# Service Bulletin

Bulletin No.: PIC5360B

**Subject:** Intermittent No Crank No Communication To High Speed LAN Modules

**Models:** 2010 - 2013 Chevrolet Camaro

2503475

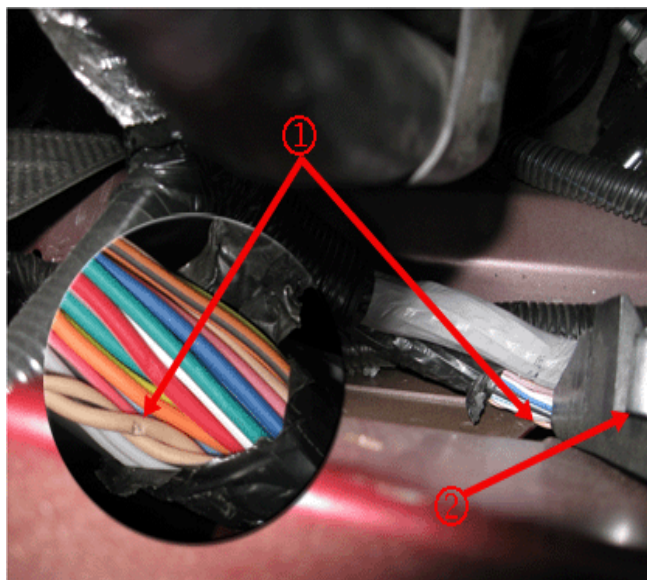
There are two (2) locations on the vehicle to inspect for this concern depending on what options it is equipped with. The first area of concern is the engine wiring harness (1) under the ECM (2). Technicians are to check for possible chaffing of this wiring harness on the inner fender panel. An example of this concern can be seen in the photo below.

Repair the wiring, install conduit on this area of the harness, and relocate the harness away from the panel to protect it from future damage.

3226239

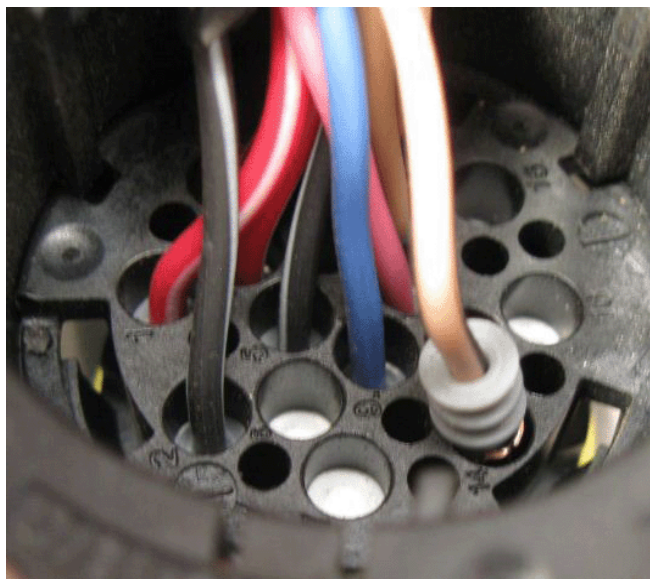
The second area of concern relates to vehicles equipped with an automatic transmission only. Reports from the field have shown that a HSLAN circuit terminal may not be seated properly in the round TCM connector located in the transmission. Technicians are to inspect this TCM connector for any data line circuits that may be not fully seated in the plastic connector. If this concern is found, carefully inspect the condition of both halves of the plastic connector

The two photos below show an example of circuit 2500 backed out of the TCM connector. Be sure to inspect ALL terminals in this connector while it is disconnected.

as well as both the male and female terminals. If the female terminal was simply not seated correctly, push on the wire until the terminal clicks back into position. Lightly tug on the wire to make sure it is fully seated. If it pulls back out, replace the terminal and/or connector as needed. After reinstalling the connector to the TCM, lightly tug on the wire again to make sure it did not become disengaged during reassembly. If the male terminals or the TCM half of the connector is damaged, the entire TCM will require replacement. This module is internal to the automatic transmission assembly.
